## **SUN PAWS SUBDIVISION**

APPLICATION NUMBER 6 DATE May 17, 2018

REQUEST Subdivision

## DETAIL SITE PLAN

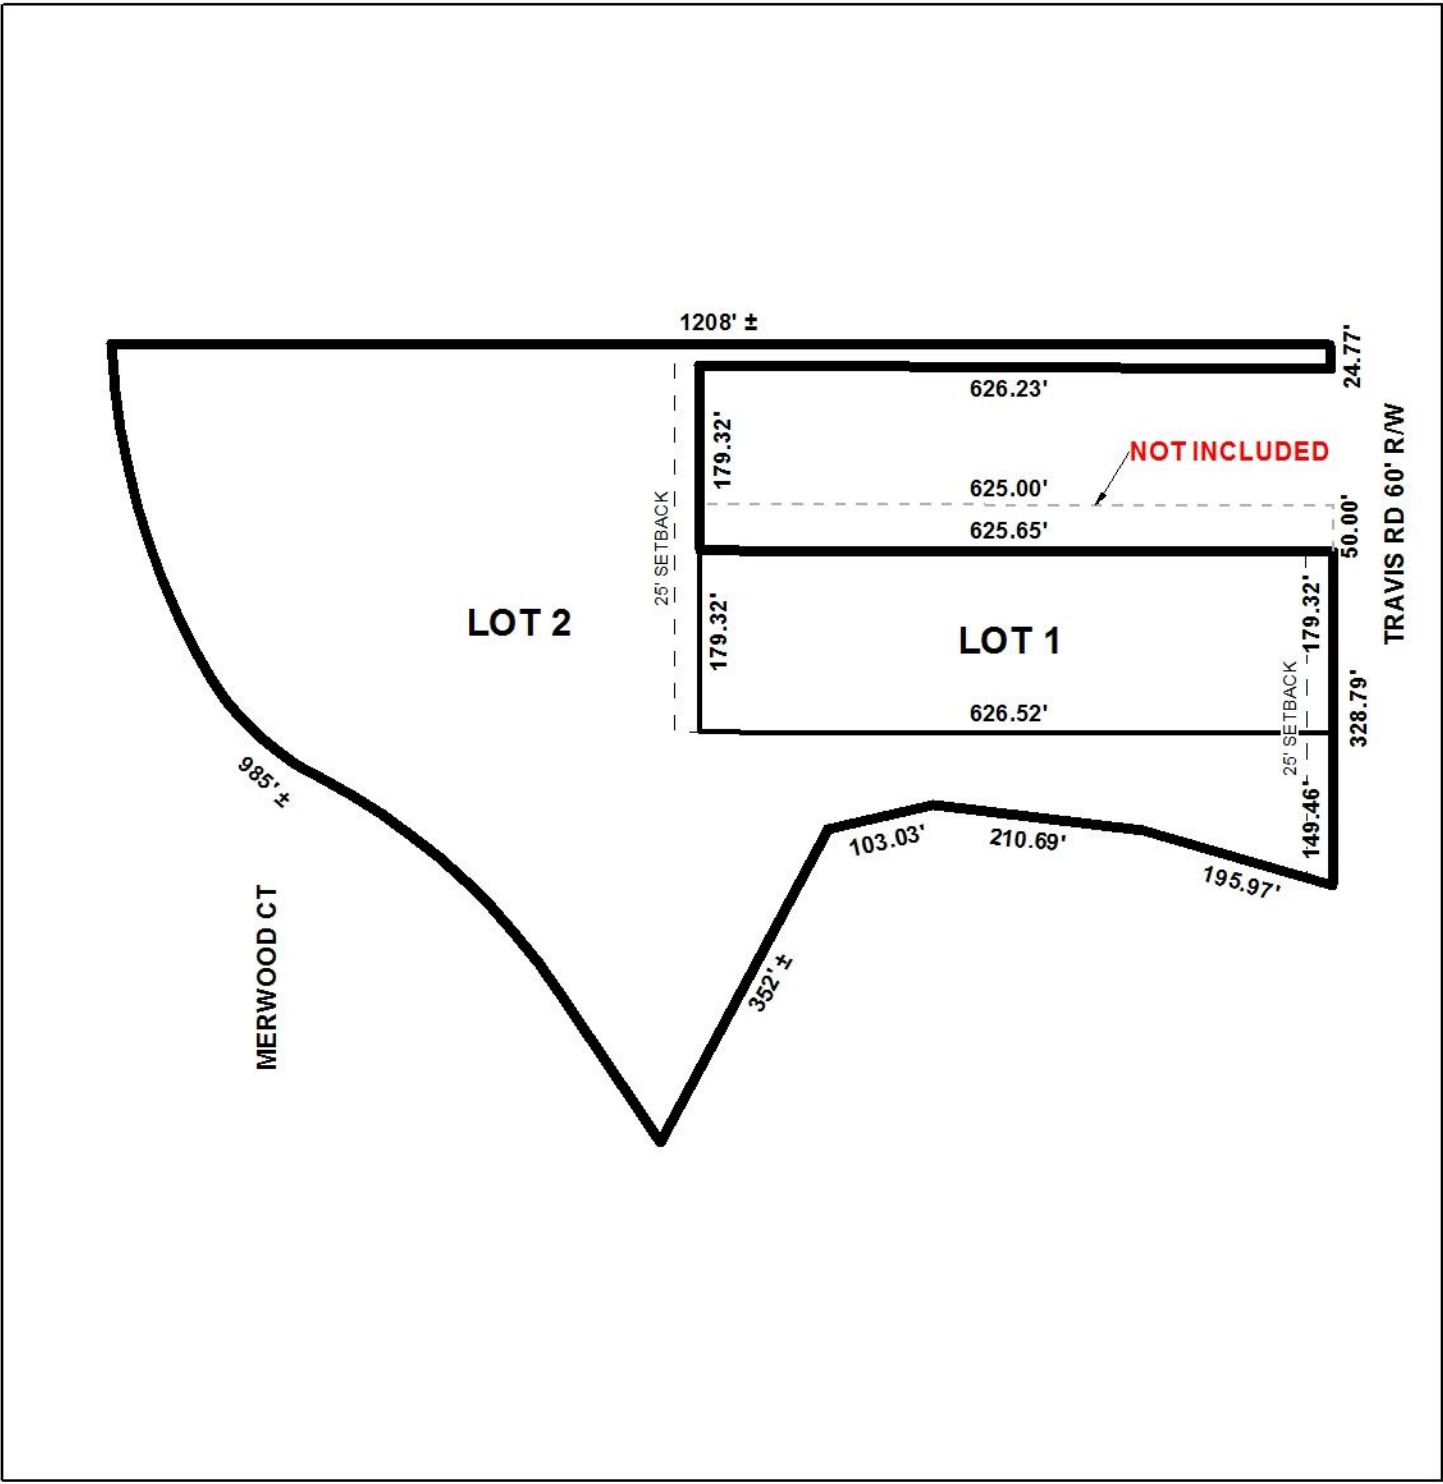
The submitted preliminary plat excludes a portion of one of the legal lot from which new lots are proposed to be subdivided, but not as an additional legal lot. No justification was provided for the exclusion of a portion of the previously approved low. Research by staff shows that a 56' X 626' area was deeded to an adjacent property owner in 2013 without going through the Subdivision process. As such, holdover of the request may be appropriate to allow the applicant to include the remainder of the lot from which Lot 1 is proposed to be subdivided, either as a portion of the subject site, or as an addition to an adjacent lot.

Lot 2 is irregularly shaped as a result of proposing to combine two (2) previously approved, irregular lots, one (1) of which is a flag lot. As such, it would have two (2) frontages along Travis Road: 25' to the North of the site, and 149.46' to the South of the Site. Lot 2 would also have frontage along Merwood Court, to the West of the site. Lot 1 would have frontage only on Travis Road. Both Travis Road and Merwood Court are minor streets without curb and gutter requiring 60' right-of-way widths. Adequate right-of-way is depicted along Travis Road, but not along Merwood Court. Previous subdivision of the site did not require dedication of the right-of-way along Merwood Court, but access to the street was denied; therefore, a note should be placed on the Final Plat, if approved, stating Lot 2 is denied access to Merwood Court.

Regarding access management, proposed Lot 1 should be limited to one (1) curb cut to Travis Road, and proposed Lot 2 should be limited to two (2) curb cuts to Travis Road. Any changes in the sizes, locations or designs of any curb cuts should be approved by Mobile County

One (1) portion of the frontage of Lot 2 along Travis Road is large enough to be potentially re-subdivided and, in accordance with Section V.D.3. of the Subdivision Regulations is not exclusive of unusable land, thus contributing to a depth more than 3.5 times its width at its potential building setback. The remainder of the frontage of Lot 2 is small enough to also contribute to a depth of the lot greater than 3.5 times its width. In addition to exceeding the maximum width-to-depth ratio of the Subdivision Regulations the site, as mentioned, is irregularly shaped. While such a design is inconsistent with other lots in the vicinity, previous approval of the subdivision may indicate additional approval of the lot, as illustrated, is appropriate; however, the site will require a waiver of Section V.D.3. of the Subdivision Regulations to do so.

Both lots satisfy the minimum size requirements of the Subdivision Regulations for lots served by public water and sanitary sewer systems, and are appropriately labeled in square feet and acres on the preliminary plat (with the exception of the excluded portion of proposed Lot 1). The 25' minimum building setback line along Travis Road where the lots are at least 60' wide is also illustrated. If approved, this information should be retained on the Final Plat.

*With a waiver of Section V.D.3. the proposed plat meets the minimum requirements of the Subdivision Regulations and is recommended for Tentative Approval, subject to the following conditions:*

- 1) placement of a note on the Final Plat stating Lot 2 is denied access to Merwood Court;*
- 2) placement of a note on the Final Plat stating Lot 1 is limited to one (1) curb cut to Travis Road, and Lot 2 is limited to two (2) curb cuts to Travis Road, with any changes in their sizes, locations, or designs to be approved by Mobile County Engineering and conform to AASHTO standards;*

- 3) retention of the lots sizes in square feet and acres on the Final Plat, or provision of a table providing the same information;*
- 4) retention of the 25' minimum building setback line along all Travis Road;*
